ENGINE - FUEL AND CONTROL - ENGINE FUEL AND CONTROL - FUEL METERING UNIT - INTRODUCTION
OF FUEL METERING UNIT WITH REVISED HP SOV TORQUEMOTOR - CATEGORY CODE 7 -
MOD.ENG-73-0107

NUMBER FMU 530-73-8037

ENGINE - FUEL AND CONTROL - FUEL METERING UNIT - INTRODUCTION OF THE SERVOVALVE-SOV WITH 87 OHM MINIMUM COCKPIT COIL WINDINGS

NUMBER FMU 500-73-8052

BEFORE MODIFICATION

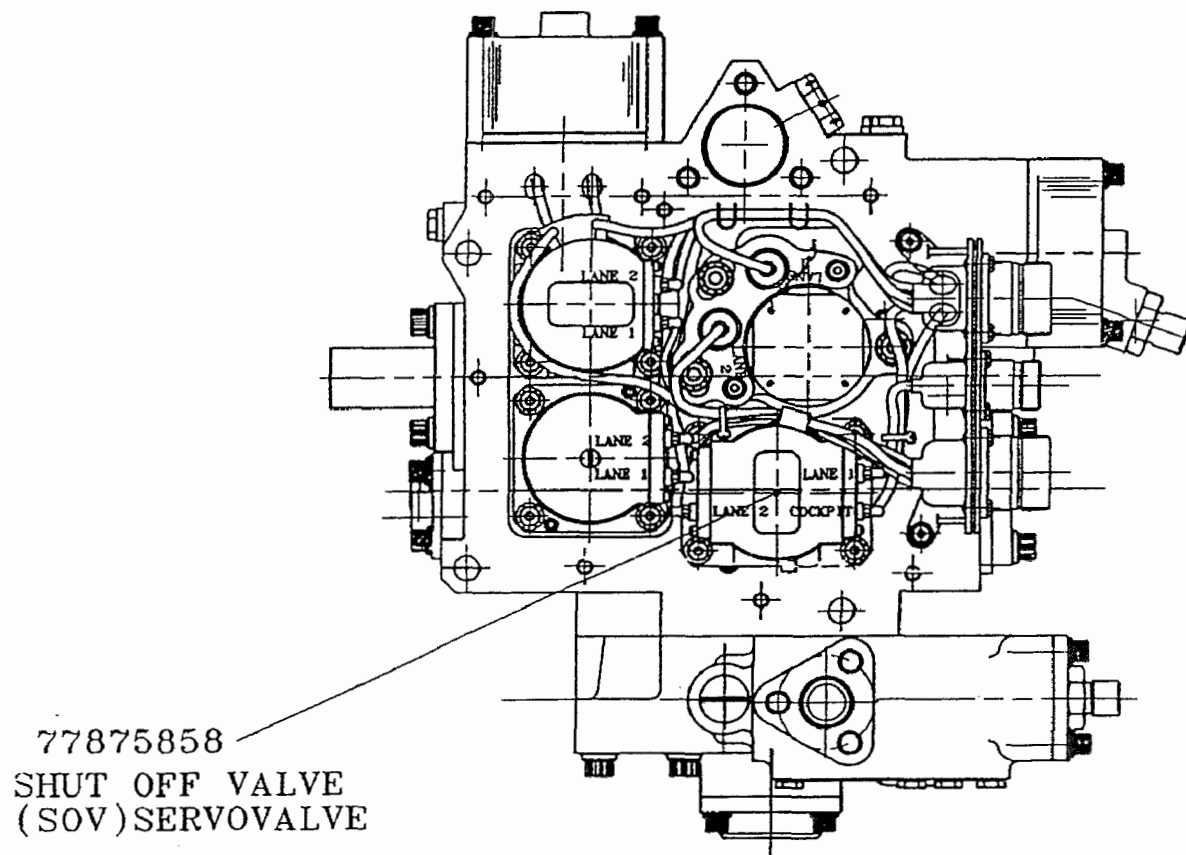
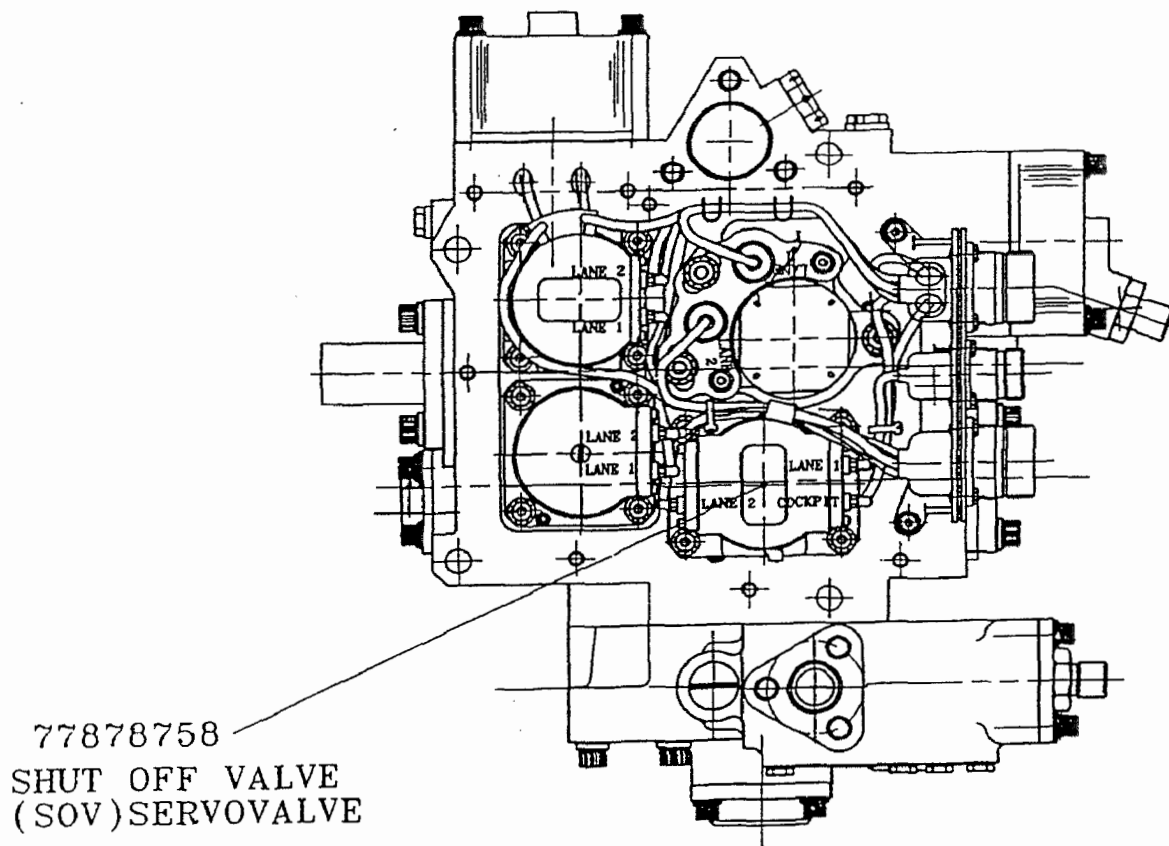
This Service Bulletin (Modification) introduces a servovalve-SOV with an increased number of winding turns on the two parallel "cockpit/pilot" coils. Each coil has a minimum resistance of 87 Ohm.

Assemble post CP8037 parts to the FMU in accordance with the CMM (1.K. References) and Figures of this Service Bulletin.

BEFORE MODIFICATION

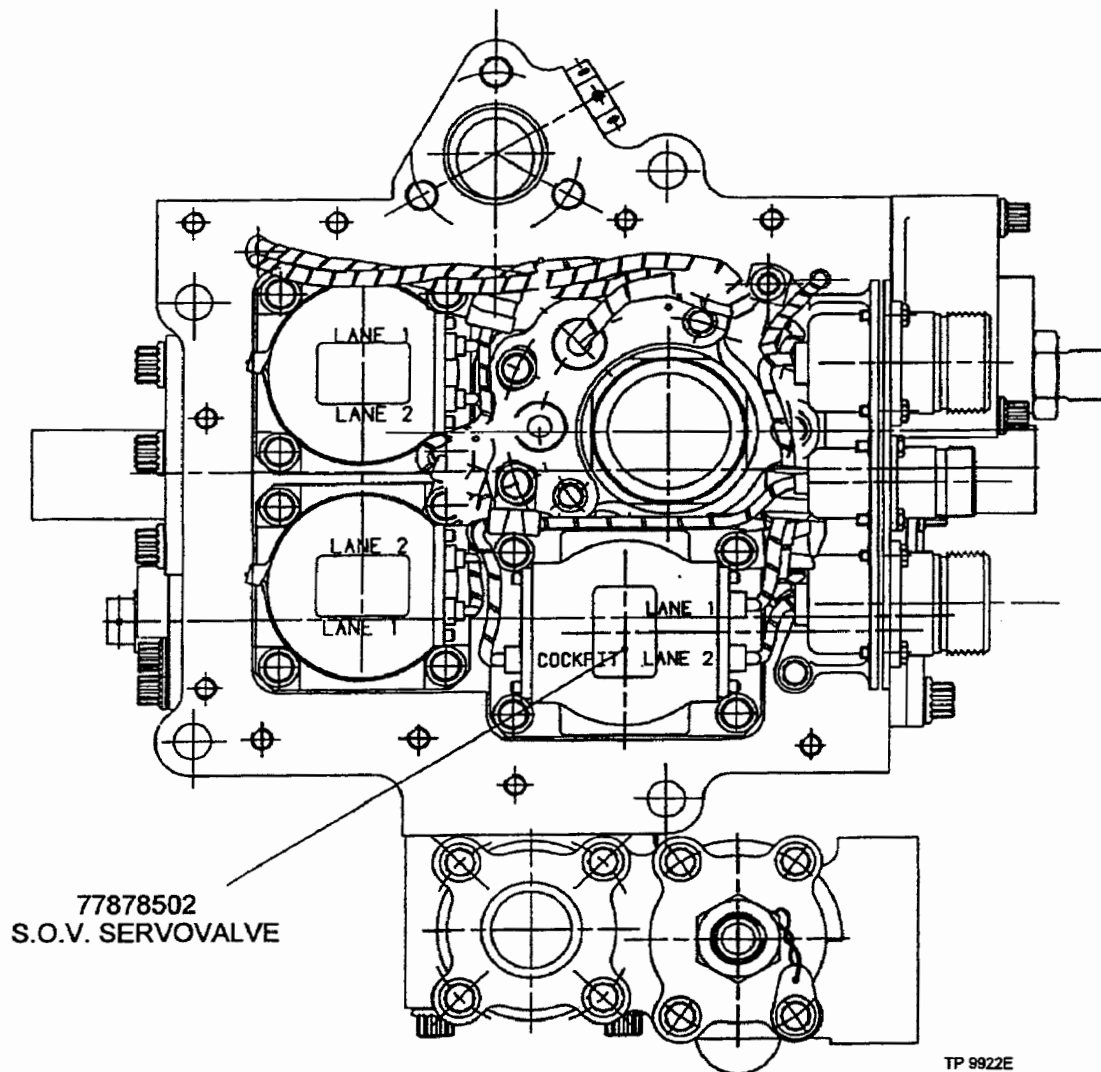
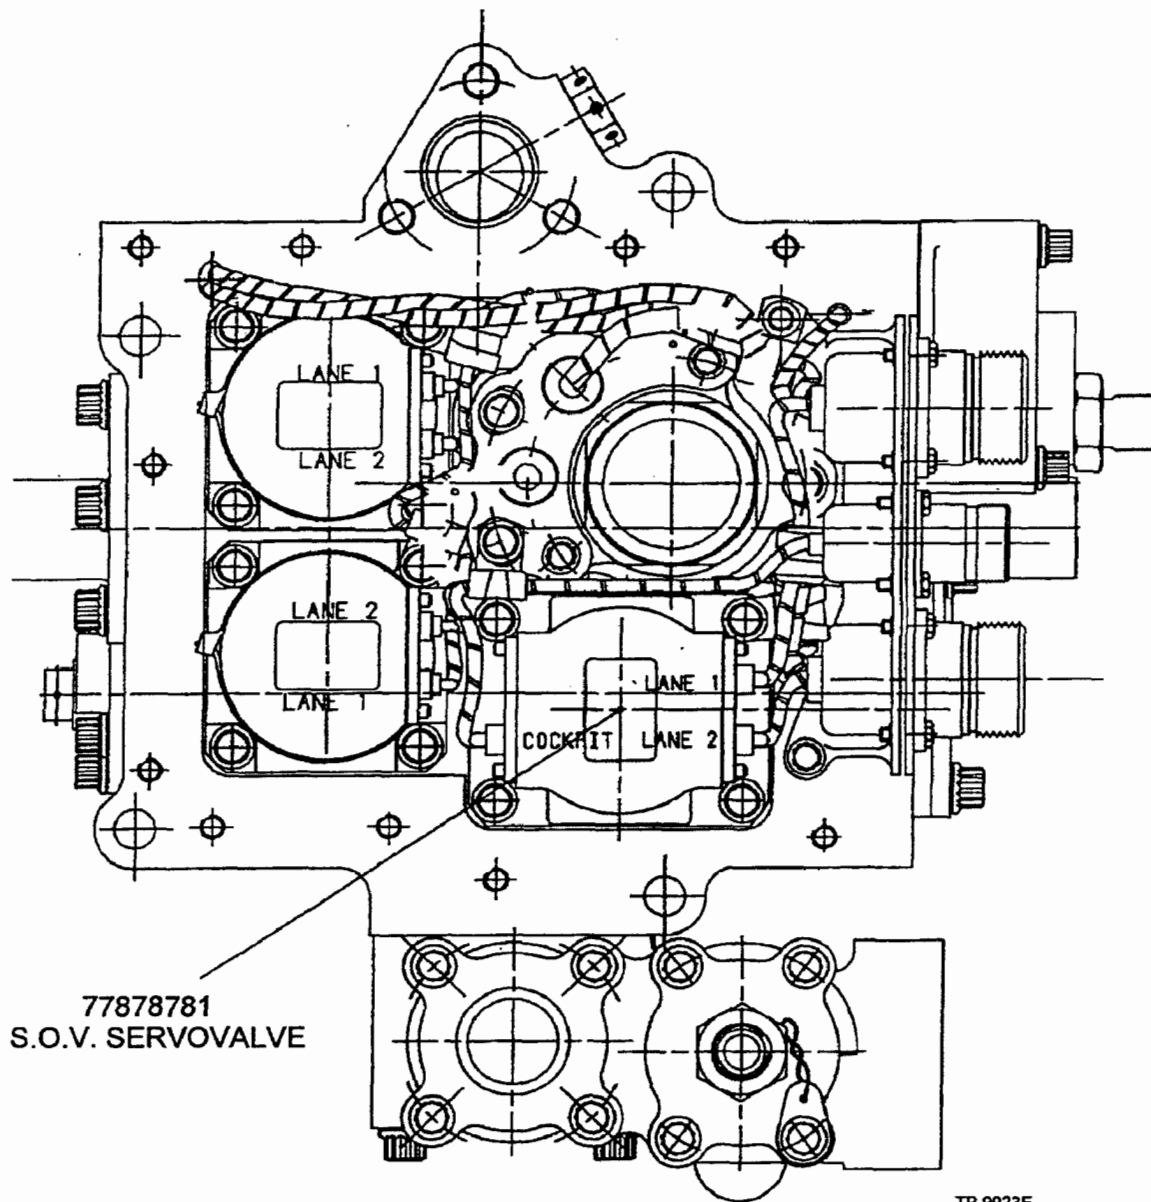
This Service Bulletin (Modification) introduces a servovalve-SOV with an increased number of winding turns on the two parallel "cockpit/pilot" coils. Each coil has a minimum resistance of 87 Ohm.

Assemble post CP8052 parts to the FMU in accordance with the CMM (1.K. References) and Figures of this Service Bulletin.
